Detailed Site Plan
Departure from Design Standards
Alternative Compliance
The Herman Apartments

DSP-22017
DDS-24003
AC-25009

STAFF REPORT

SUBJECT: Detailed Site Plan DSP-22017
Departure from Design Standards DDS-24003
Alternative Compliance AC-25009
Type 2 Tree Conservation Plan TCP2-023-2025
Variance to Section 27-442(c)
The Herman Apartments

Figure 1: Site Plan

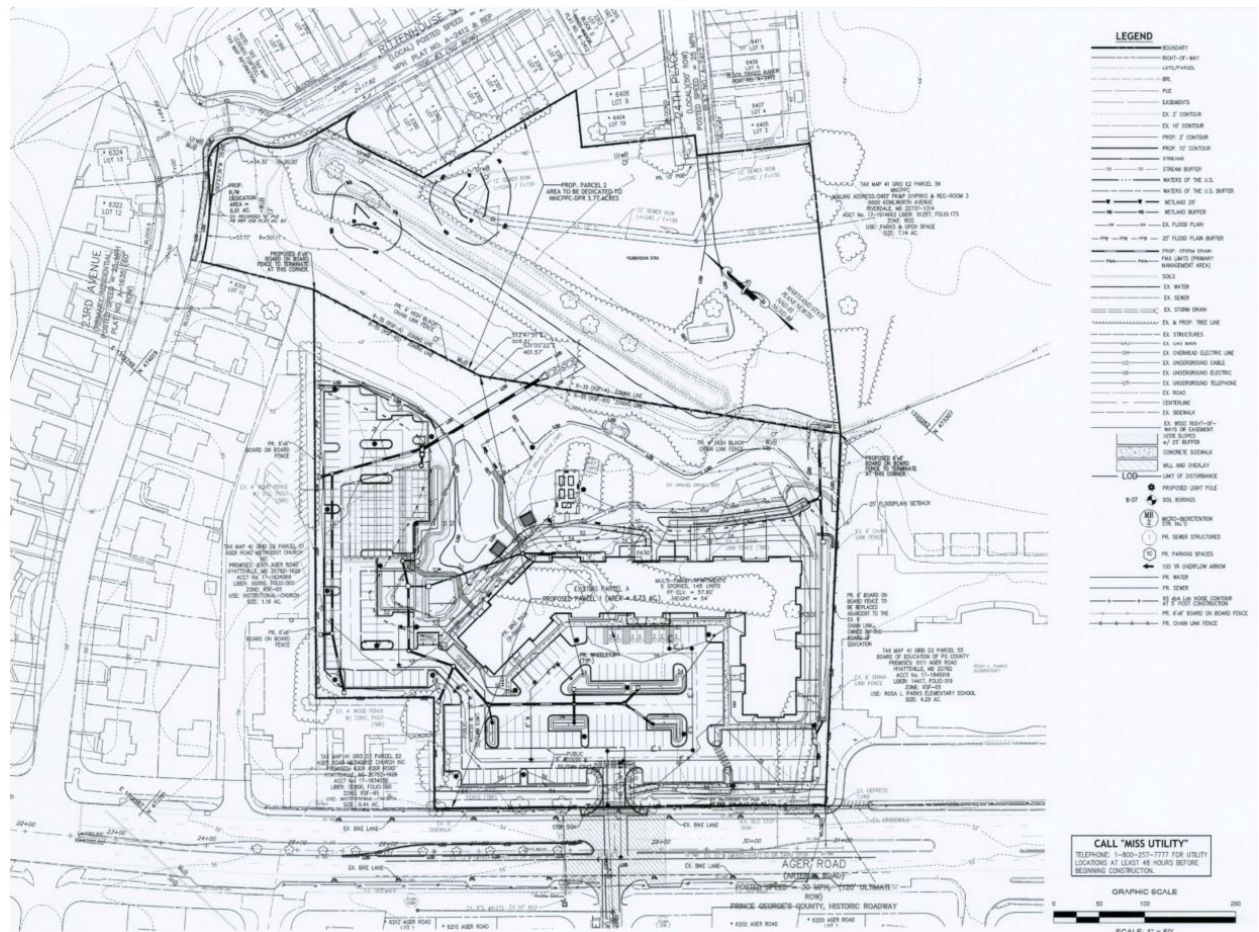
6. **Design Features:** The DSP proposes development of 145 multifamily dwelling units within one 5-story building, with one vehicular access driveway from Ager Road. The proposed multifamily building with associated infrastructure and amenities will be developed on the proposed Parcel 1. Proposed Parcel 2 will be dedicated to M-NCPPC, to add onto the stream valley parkland, located on abutting Heurich Park. Due to the existing environmental features on the northern portion of proposed Parcel 1, the proposed multifamily building on Parcel 1 will be located south of the 100-year floodplain and its buffer area, facing a parking area that will occupy the western and southern portions Parcel 1.

The multifamily building is designed in an approximately L-shaped configuration, with two wings and a central, south-facing main entrance that leads to the parking area. The periphery of Parcel 1 adjacent to other parcels will be enclosed with a fence. According to the architectural floor plan, there are stairway entrances at both the west and east sides of the building, an entrance providing access to the patio area at the rear/north side, and three entrances to utility rooms. The front and back area of the building will be improved with

landscaping and internal sidewalks, providing pedestrian access to the parking area and amenities located at the rear of the building. Striped crosswalks are proposed at the vehicular entry/exit point and between proposed internal sidewalks and the sidewalks outside of the parking area for pedestrian connectivity. The dimension of the proposed sidewalk is not labeled on the DSP. A condition is included herein requiring the applicant to add dimensions to the proposed sidewalk surrounding the proposed building.

Figure 5: Floodplain acreage comparison with surrounding properties

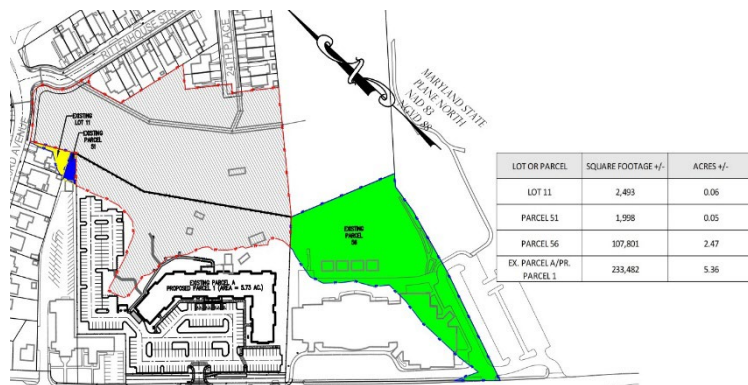
The applicant further provides a graphic showing the area of floodplain on the subject property (outlined in red), compared to the floodplain area on neighboring properties (shown in green, blue, and yellow).

In addition, the applicant argues that the subject property is unique because development of surrounding properties did not have the same regulatory limitations based on floodplain and stream buffers, due to these flood-impacted properties already being developed before floodplain regulation was adopted. Floodplain areas are generally unbuildable under the Federal Emergency Management Agency (FEMA), state, and local regulations, which often prohibit construction or impervious surfaces in these areas. Based on historical aerial images, the surrounding properties were fully developed circa 1960s. Of the surrounding properties that are impacted by floodplain, the subject property is the only property that is not zoned as Reserved Open Space (R-O-S) and remains undeveloped since the adoption of the floodplain regulations in 1989, and the enactment of
